Request for Additional Information No. 525(6194, 6154), Supplement 11

U.S. EPR Standard Design Certification

SRP Section: 09.01.04 - Light Load Handling System (Related to Refueling)

Question 09.01.04-29:**OPEN ITEM**

Figure 09.01.04-29-1
SFCTM Anti-Seismic Locking Device

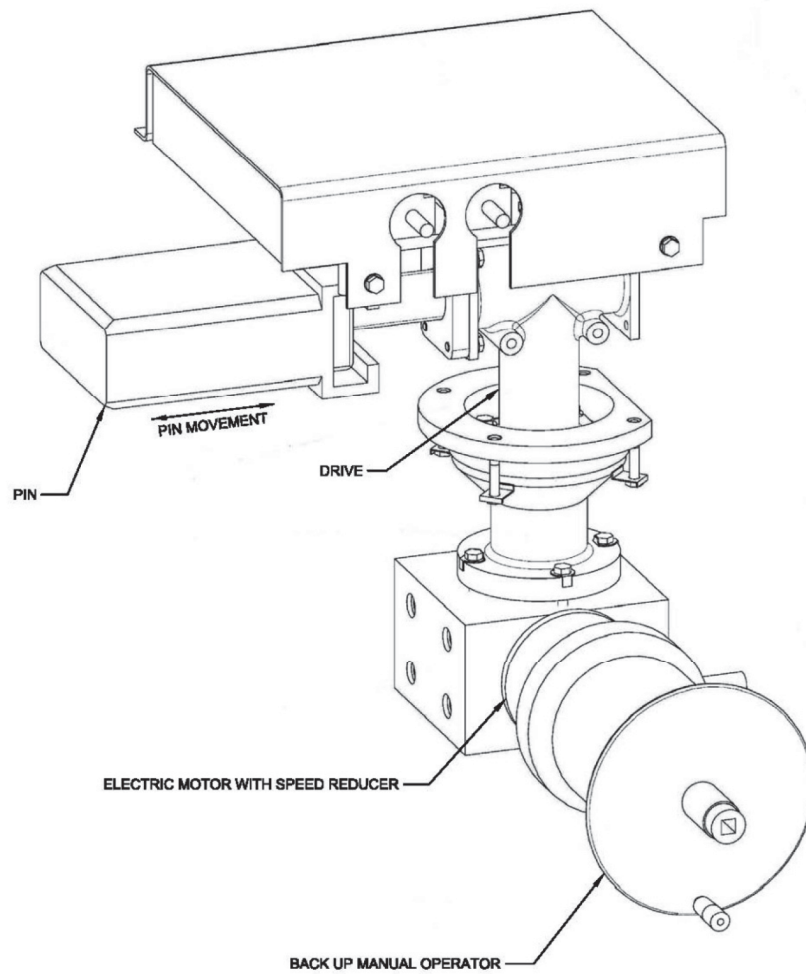
The spent fuel cask transfer facility (SFCTF) includes two pieces of mechanical equipment which are 1) spent fuel transfer machine (SFCTM) and penetration assembly, to ensure safe transfer of spent fuel assemblies from the spent fuel pool into the spent fuel cask. US EPR FSAR Revision 4 Interim, Section 9.1.4.2 (August 31, 2011, Response to RAI 385) provides detailed description of the functional features of the SFCTF and stated that both pieces of the SFCTF equipment be designed as Seismic Category I. However, insufficient information is provided regarding the structural aspects of the SFCTF design. To facilitate the structural review of the SFCTF design, the applicant is requested to provided the following :

- a. Description of overall dimensions, structural elements (beams, girders, trusses, plates, etc.) and their connections for the SFCTM and the penetration assembly, including sketches.
- b. Description of the anti-seismic locking devices including their connections with the SFCTM and the structural walls (provide sketches).
- c. Overall dimensions and structural description of the loading hall (concrete walls and slabs) including sketches.

The lateral guiding devices and anti-seismic locking devices are fixed at two sides of the SFCTM frame structure. The SFCTM lateral guiding devices and anti-seismic locking devices are designed to Seismic Category I criteria.

The anti-seismic locking device consists of a movable part that engages inside the openings in the guiding rails at the handling opening, the lid lifting station, and the penetration station. The guiding rails are attached to the corbels of the loading hall. The movable part of the anti-seismic locking device is actuated by a screw/nut system connected to an electric motor, a reduction gear, and a torque limiter. The screw movement is not possible without an external action. The anti-seismic locking devices are also equipped with a manual backup for operation in case of a loss of electric power. The position of the moveable part (locked/unlocked) is detected by a sensor. The anti-seismic locking devices, when engaged in the openings in the guiding rails at the handling opening station, the lid handling station, or the penetration station, prevent any movement of the SFCTM in the event of a seismic event or spurious behavior of the SFCTM traveling drive system.

Figure 09.01.04-29-1—SFCTM Anti-Seismic Locking Device provides an overview of the SFCTM anti-seismic locking device.
